SUBJECT: REQUEST FOR ADDITIONAL INFORMATION LETTER NO. 387 RELATED TO
ESBWR DESIGN CERTIFICATION APPLICATION

**Requests for Additional Information (RAIs):
ESBWR Design Control Document Revision 6**

TER for GE-Hitachi's Setpoint Methodology NEDE-33304P

Fig. 2. Standard normal distribution showing the upper and lower 2.5% tails.

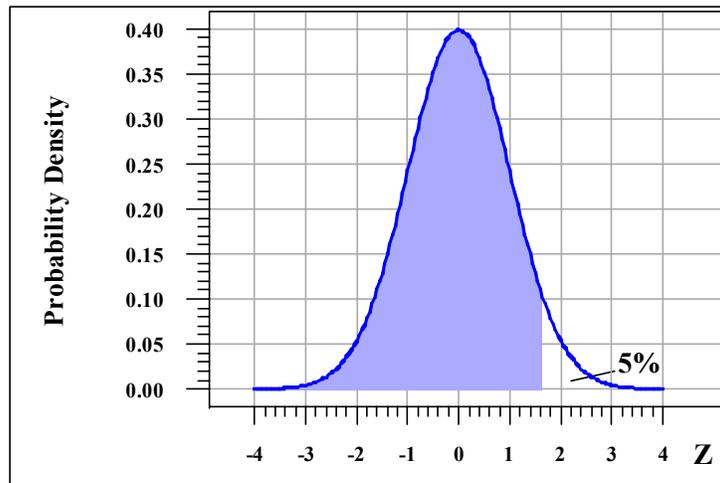
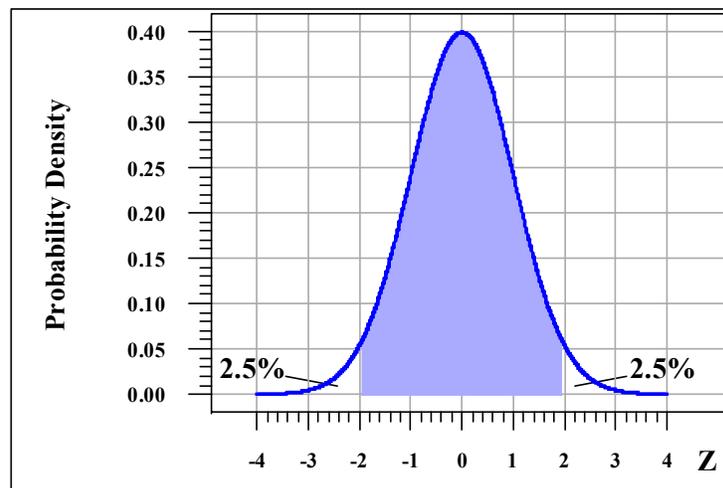
The statement that "95% of the data points will be bounded by the value selected" can be met by either the one- or two-sided tests as shown in Figs. 1 and 2. The second part of the

statement—that this corresponds to an error distribution approximately equal to a “two sigma” value—applies to the two-sided test as shown in Fig. 2 because the 2σ sets the tails at 2.5 percent. Based on this, the prescribed limit of 95/95 in RG 1.105, Rev. 3 seems to refer to a two-sided test (footnote ⁵), which means the tails are each 2.5 percent. The corresponding limit for a one-sided test would be 97.5/97.5. As such, the proposed setpoint methodology fails to meet the intent of RG 1.105, Rev. 3.

**Fig. 3. One-sided vs. two-sided 95/95 trip setpoints.
(AL = analytical limit and NTSP = nominal trip setpoint)**

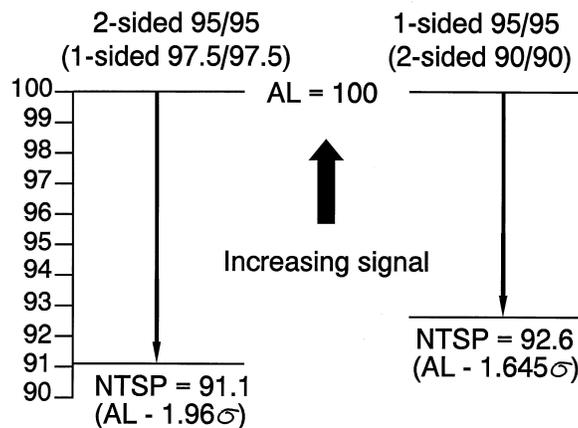
The difference between setpoints determined when applying the same 95/95 tolerance limit to the upper/lower end of a two-sided test and a one-sided test is shown in Fig. 3. Because the one-sided test places all of the uncertainty at one end of the distribution (as shown in Fig. 1), a one-sided test with a 95/95 tolerance limit is comparable to a two-sided test with a 90/90 tolerance limit. Consequently, the margin between the AL and the nominal trip setpoint (NTSP) decreases by ~18 percent (footnote ⁴). The inherent imprecision of the data used in uncertainty calculations, the uncertainties involved in the assumption of normality, and the effects of other uncertainties and assumptions in related analyses may reduce the trip setpoint margin even further.

Fig. 4. Histograms of uncertainty data. (FS is full scale.)

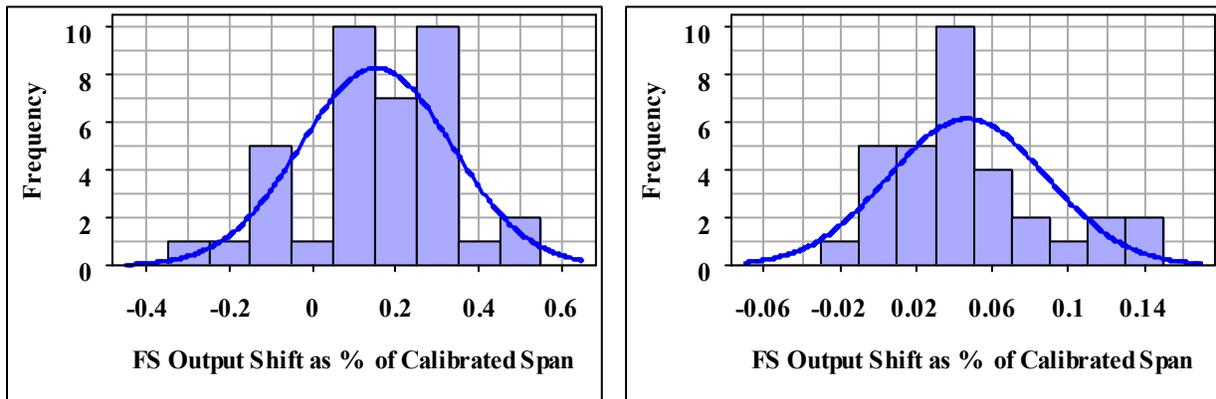
Although a normal distribution was fit to the data in Fig. 4, various goodness-of-fit tests for normality all reject the assumption that the data is normal at the .05 level of significance or less (Kolmogorov-Smirnov test, $p=.01$; Shapiro-Wilk test, $p=.049$; Cramer-von Mises test, $p=.009$; Anderson-Darling test, $p=.01$). The departure from normality here may be substantial given that it is detected with so few (38) observations. The frequencies in the second bar chart in Fig. 4 also depart significantly from normal (footnote ¹³).

If the normal distribution is inadequate, then some other distribution, such as the lognormal, may provide an adequate fit. Alternatively, questions about the underlying error distribution can sometimes be avoided altogether by using distribution-free statistical methods. Consider, for example, a sample of n measurement errors, $e_1, e_2, e_3, \dots, e_n$ determined by making n tests with the instrument and known standards. Instead of computing a mean and standard deviation from this sample, consider the corresponding order (i.e., sorted) statistics $e_{(1)}, e_{(2)}, e_{(3)}, \dots, e_{(n)}$. The probability that a new error e exceeds $e_{(i)}$ is $(n-i+1)/(n+1)$, and the probability that a new error falls below $e_{(i)}$ is also $i/(n+1)$. This can be used as the basis for distribution-free predictive
